**COUGAR CREEK
DEBRIS FLOOD RETENTION STRUCTURE**

**Supplemental Information Request Round 2
Water Act File No. 00384210
NRCB Application No. 1601**

SUBMITTED TO:
Alberta Environment and Parks
and Natural Resources Conservation Board

SUBMITTED BY:
Town of Canmore

Figure
6-1

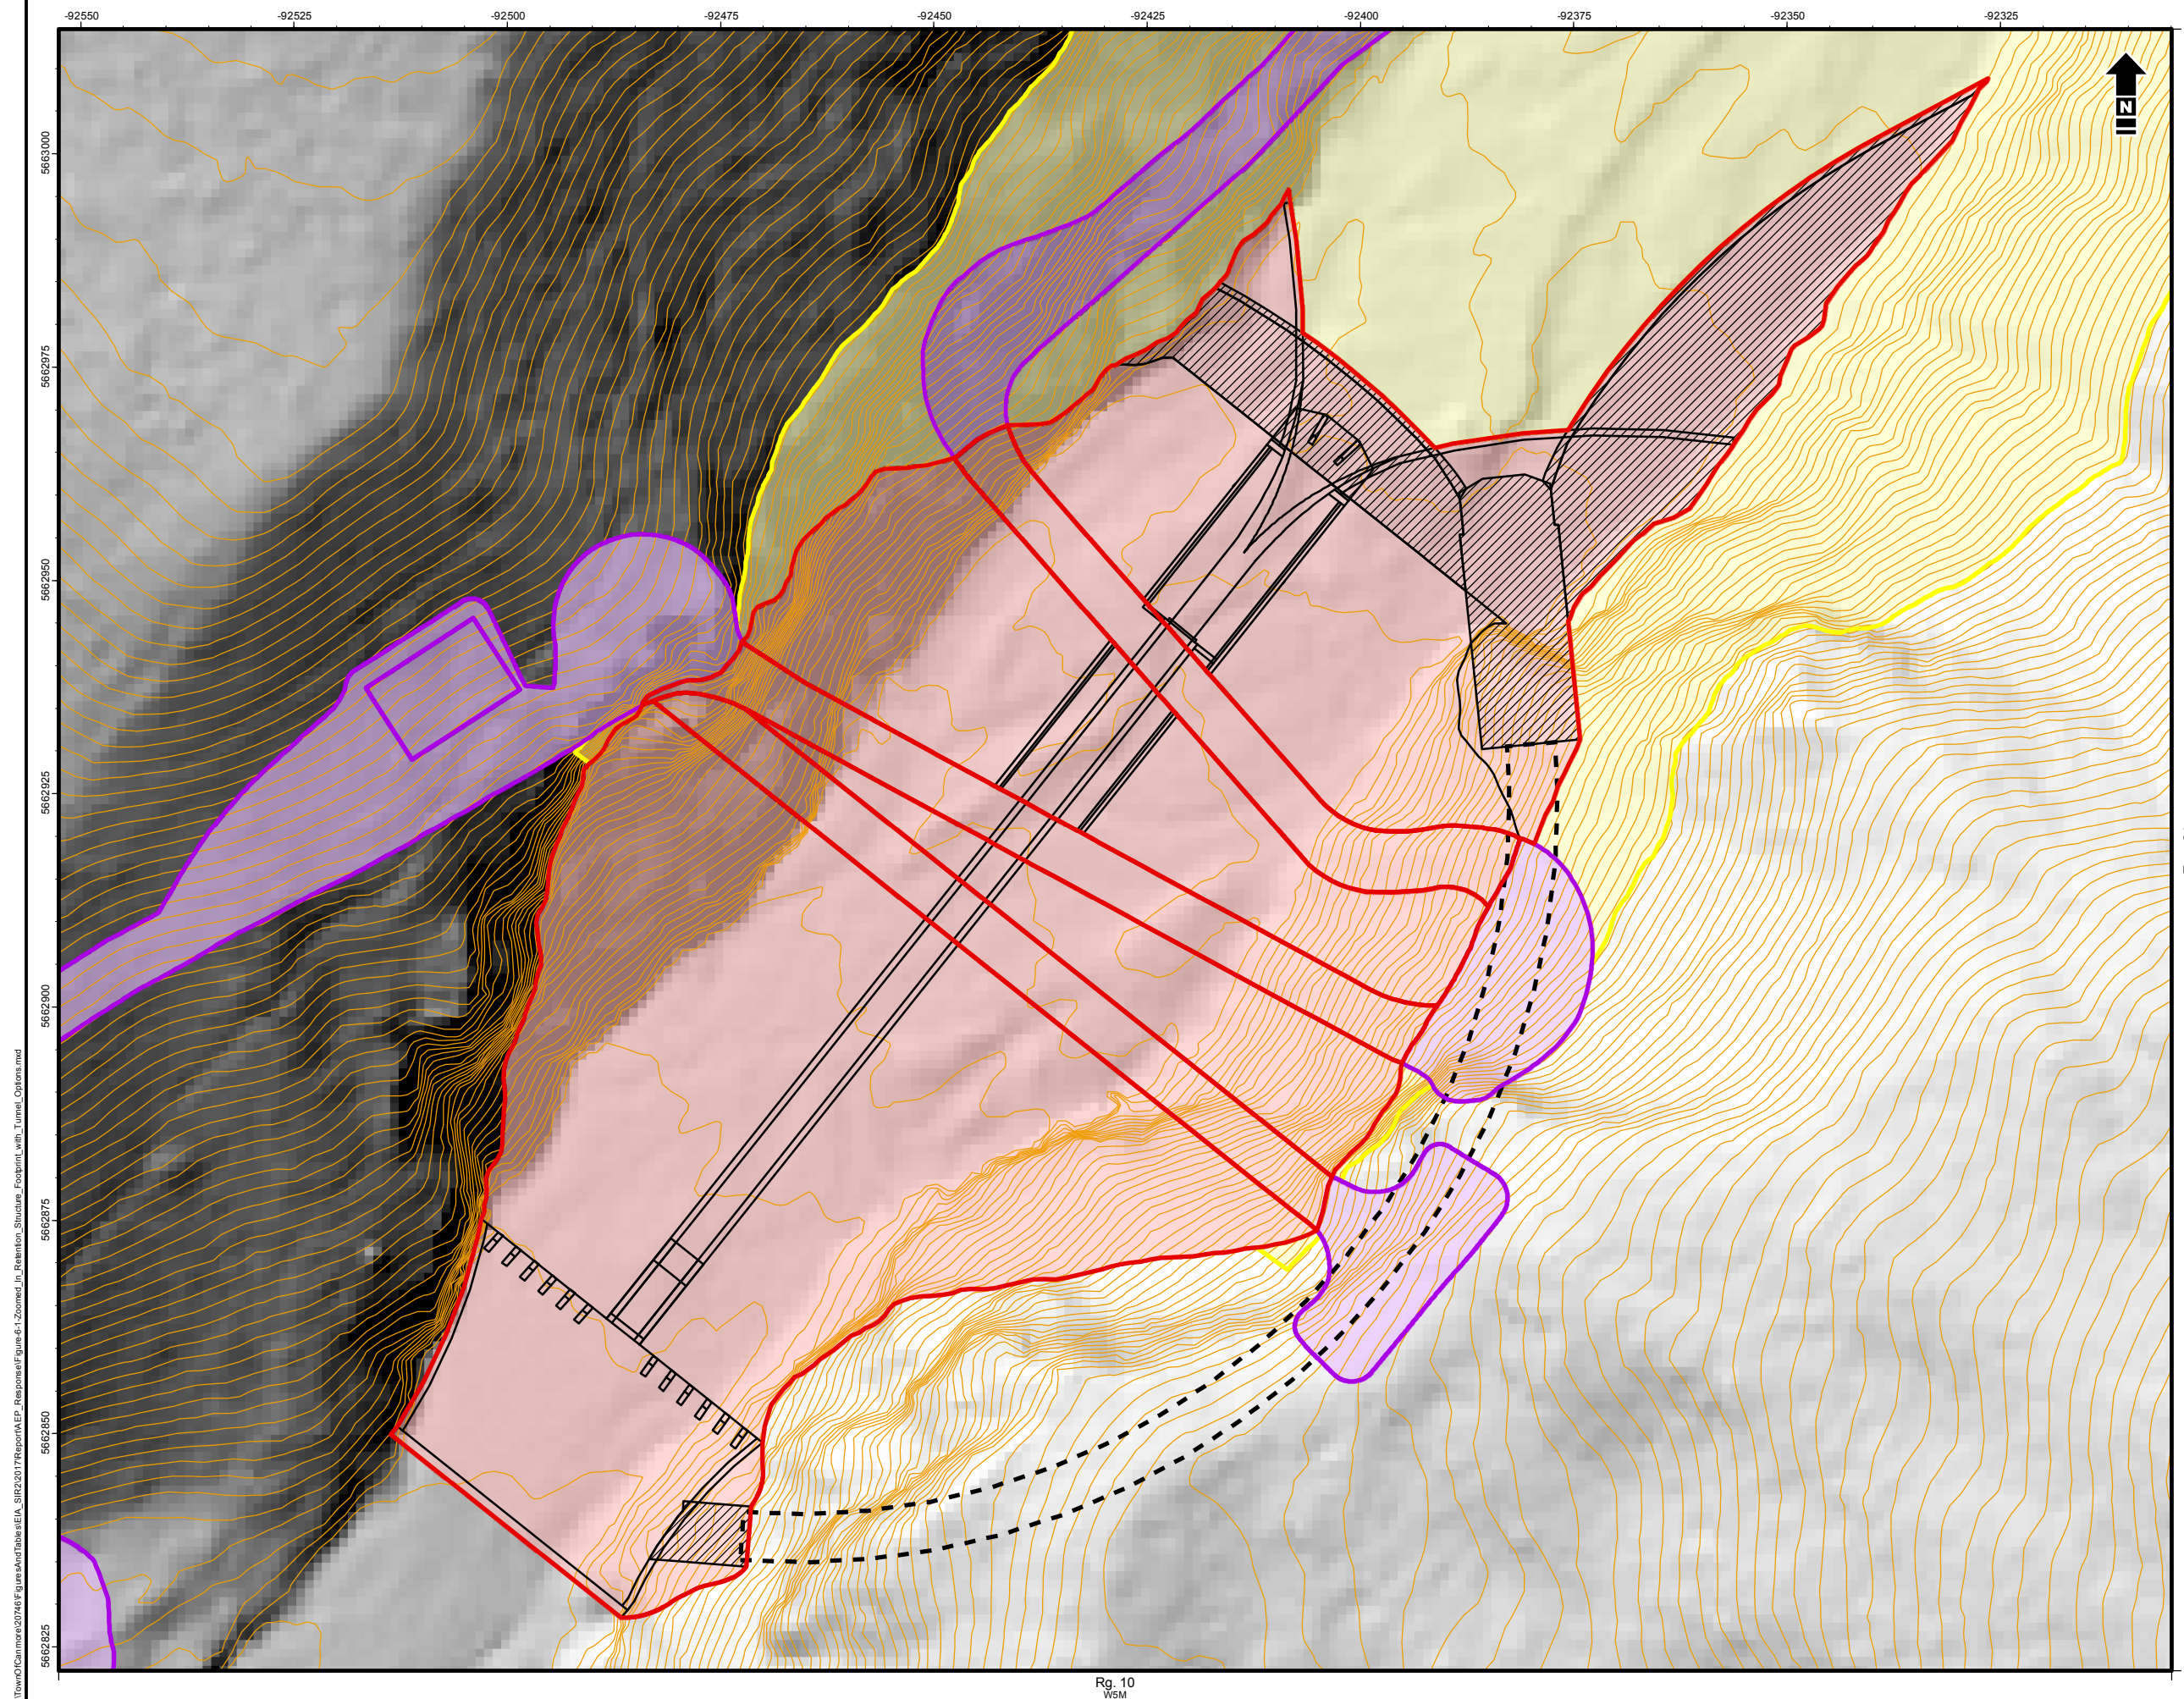
6	<p>Supplemental Information Request 1, SIR159, Page 8-6</p> <p>The overall project footprint is shown on Figure 4.1-2.</p> <p>a. Was construction access of the tunnel option included in the project footprint? If so, explain where this information is located within the EIA. Explain how the project footprint of the tunnel option includes construction access, stockpile areas, and any other areas that will be disturbed. If the tunnel option was not included in the project footprint explain why this was left out.</p>
----------	--

- a. The EIA considered a maximum footprint with both options overlaid (Figure 4.1-2 of the EIA report). This approach was described in Section 4.4.4.3 of the EIA report:

“The Town of Canmore intends to progress two outlet structure designs through the procurement process. Both options are technically feasible and serve the same function but input from experienced construction contractors was needed to confirm the relative costs of these options. For the purposes of this EIA, both options have been considered by each discipline to determine if there are any differences in potential Project effects. For the purpose of the terrestrial assessment, the Project footprint includes all potential areas disturbed by either of these two options.”

To facilitate the review of this SIR response, a zoomed in view of Figure 4.1-1 of the EIA report is presented herein as Figure 6-1. The figure presents the Structure with both outlet structure design options.

PROJECT: COUGAR CREEK DEBRIS FLOOD RETENTION STRUCTURE ISSUED FOR PERMITTING		
Figure 9-1 Dam Breach Floodwave Calculation FLOOD PROPAGATION BOW VALLEY: CANMORE - SEEBE DAM [1/7]		
PROJECT No.:	16568	REV: 01
DRAWING No.:	LTMM CC-EIA-RES-030 R01

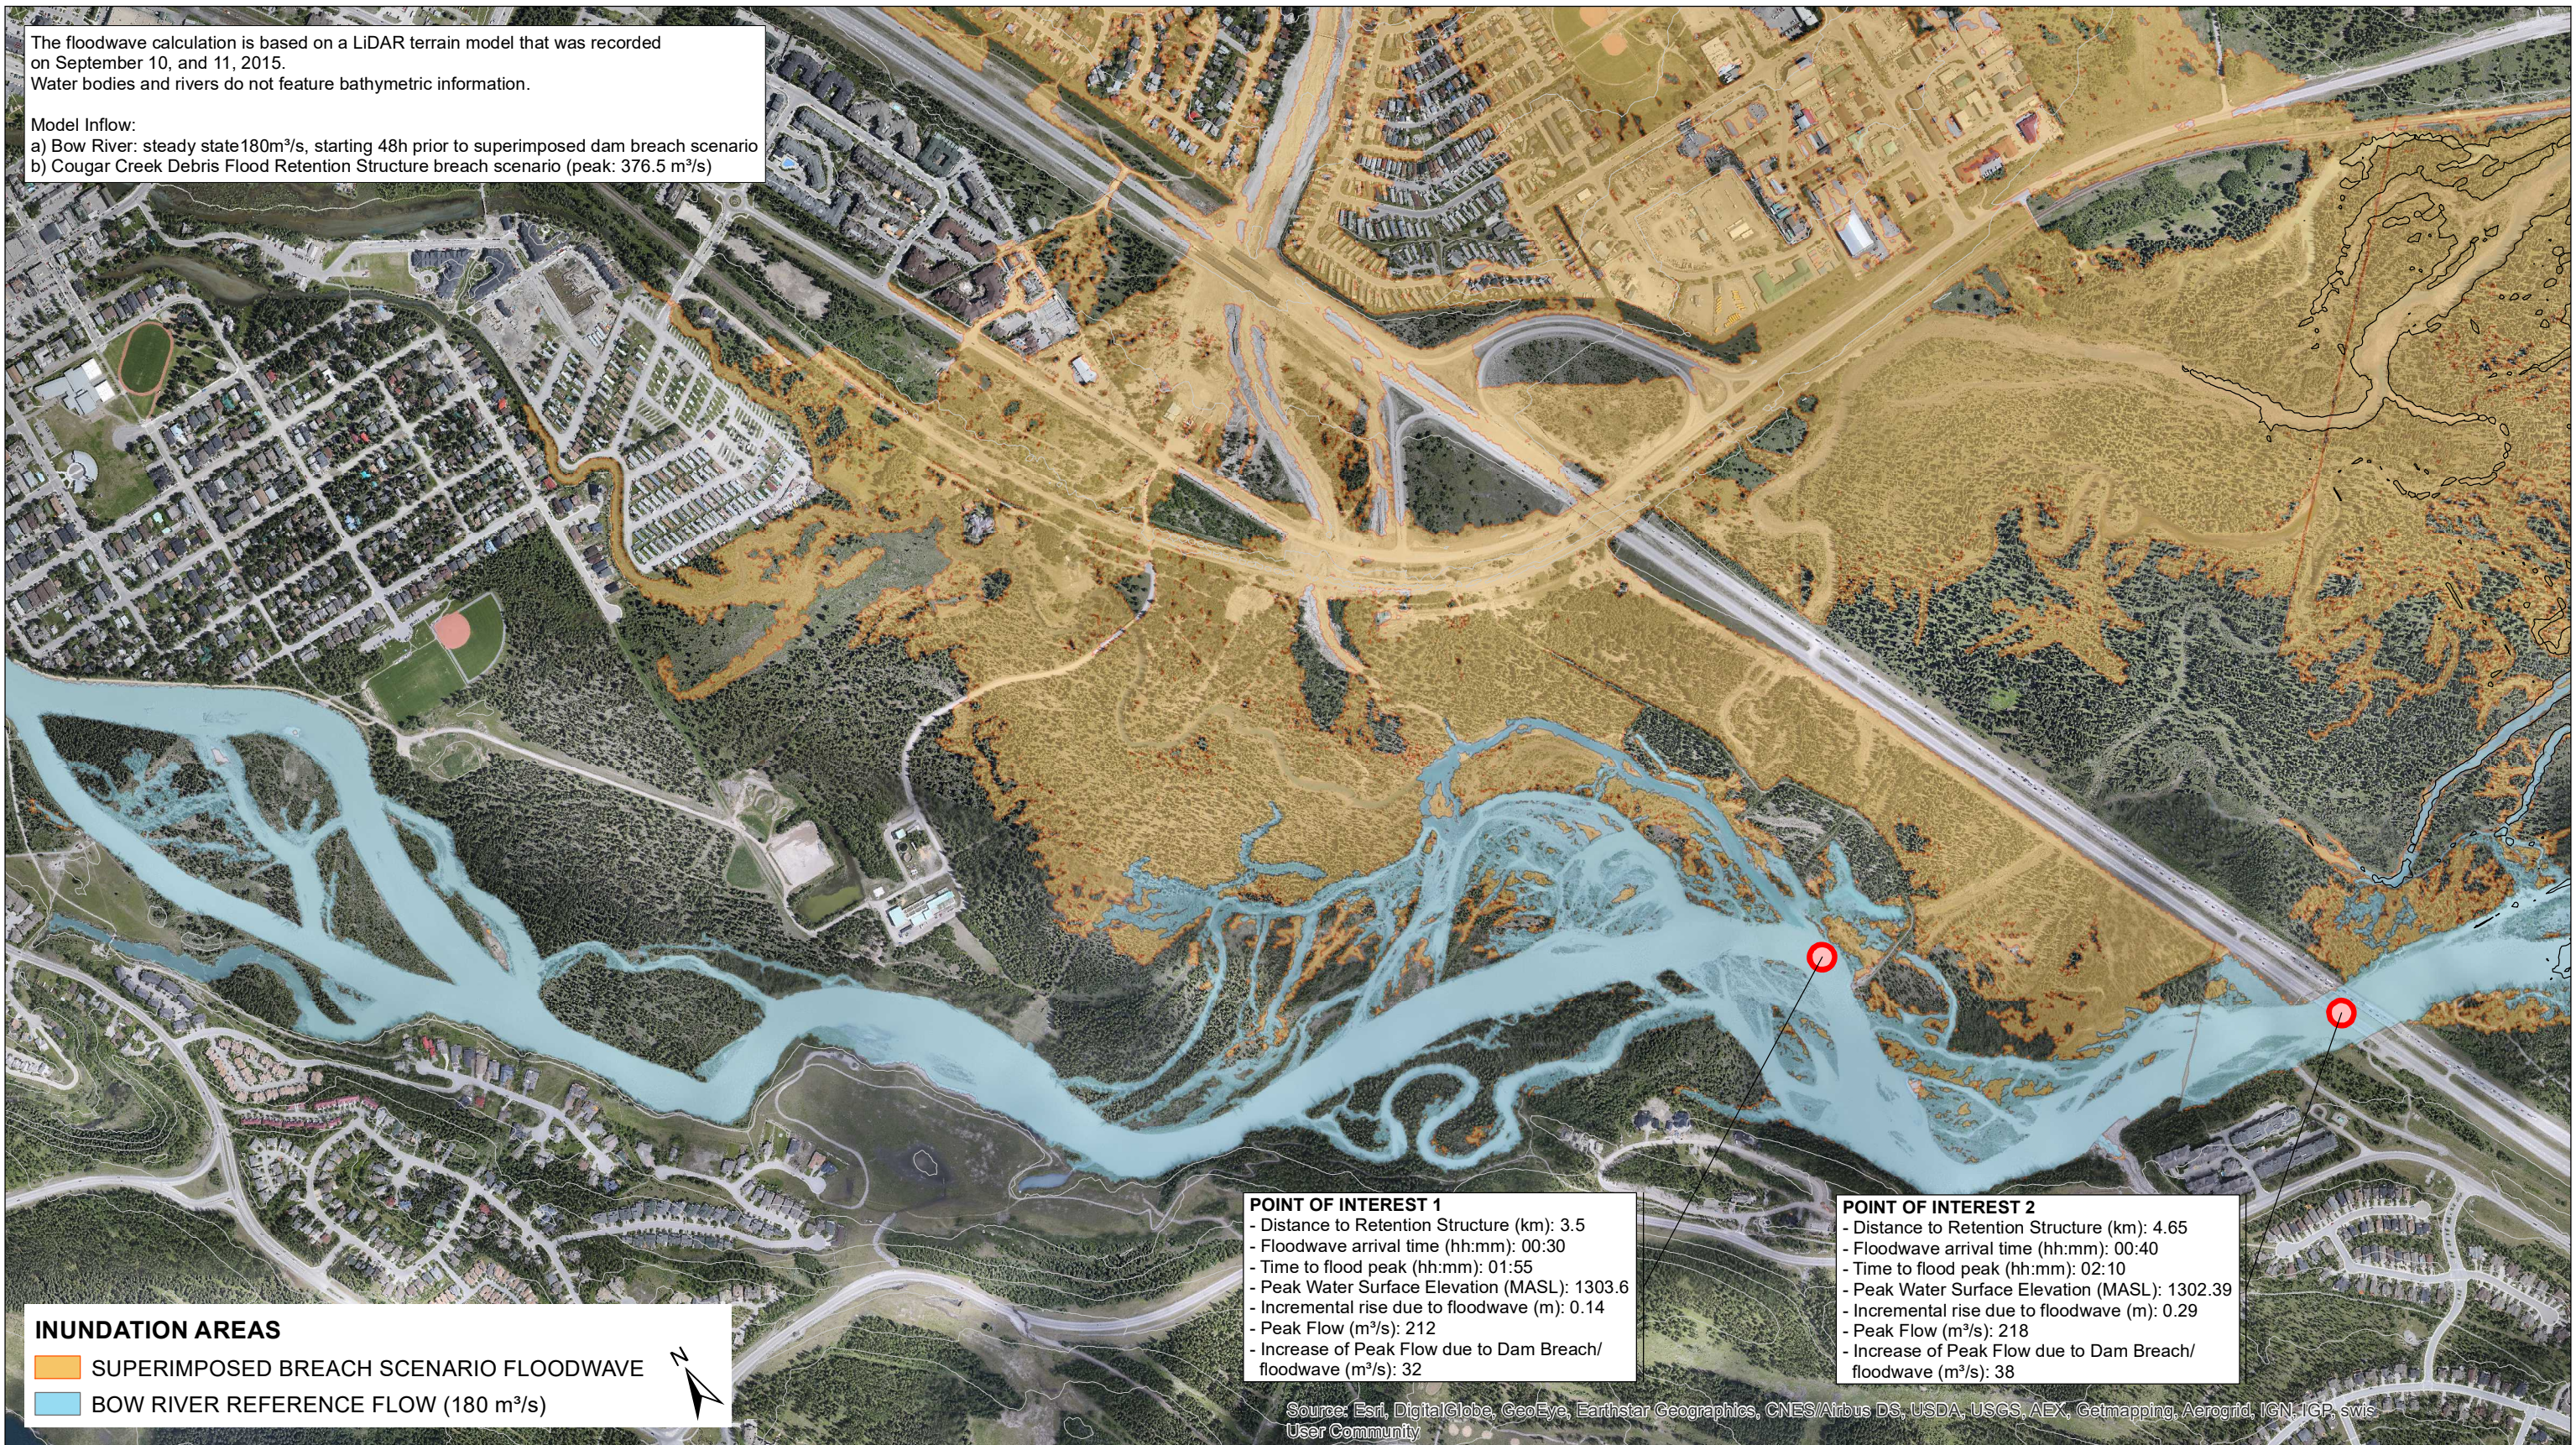
9	Final Terms of Reference, Incidents, Malfunctions and Retention Structure Safety, 7[G] a. Provide information on the potential downstream effects of a dam failure beyond the Town of Canmore. Potential effects to downstream municipalities and additional stakeholders, such as the Stoney Nakoda Nation and the Bow River Basin Council, should be added to cover off their concerns. If no concerns are expected, make the statement.
---	--

- a. A new two dimensional dam breach analysis has been performed for the Structure. The extent of the analysis is from the Town of Canmore to the TransAlta Corporation-operated Kananaskis Dam, 31.7 km downstream of the Structure. The Town of Canmore does not have bathymetric data for the Bow River that covers the full reach of the study. The analysis was therefore performed using Light Detection and Ranging (LiDAR) data from September 2015. The water surface of the Bow River during the LiDAR flight has been estimated by AEP River Forecasting to be 37 m³/s in Canmore. The Bow River baseflow used for the analysis is 180 m³/s, which represents the upper bound of the normal peak flow in the Bow Valley during spring freshet. A further 143 m³/s was therefore added to the model to recreate that required baseflow. By comparison, a similar baseflow has been used by TransAlta for modelling of all dam breach analyses in the Bow River basin in the Canmore area.

Dam breach analyses are regularly conducted downstream of dams until the incremental flood water rise is less than 30 cm. This approach ensures better consistency between different analyses instead of using a fixed distance downstream of a dam breach. The Cougar Creek dam breach analysis has been conducted well past that standard threshold to ensure that the Kananaskis Dam would not fail due to cascading effect (refer to the updated dam breach maps on Figures 9-1 to 9-7). The peak flow of the dam breach is calculated to be 376.5 m³/s at the Structure.

The potential effects of a dam failure on downstream communities and stakeholders are expected to be minimal. The closest downstream community is Dead Man's Flats, part of the Municipal District of Bighorn, approximately 7 km downstream of Cougar Creek. The increase water level in the Bow River in that area is expected to be 40 cm with a peak flow of 283 m³/s. This calculated peak flow is well below the capacity of the river in that area. For reference, during the spring of 2017, flows in Canmore exceeded 300 m³/s with no issues reported in any Bow Valley communities. This flow rate is well below a 100-year return period flow rate and according to the online Flood Hazard Map by AEP, the Dead Man's Flats community is outside of the Floodway for a 100-year return period. Finally, according to the dam breach analysis, the extra flow is contained within the existing bed and shore of the river. Therefore, a dam breach would most likely not affect the existing bank protection or the community and no concerns are expected.

The next communities to the east and downstream of Dead Man's Flats are Exshaw and Lac des Arcs, a further 7 to 12 km downstream. The increased water level in that area is expected to be between 12 and 30 cm, depending on the exact location, and to be contained within the existing bed and shore of the Bow River. Lac des Arcs acts as a very
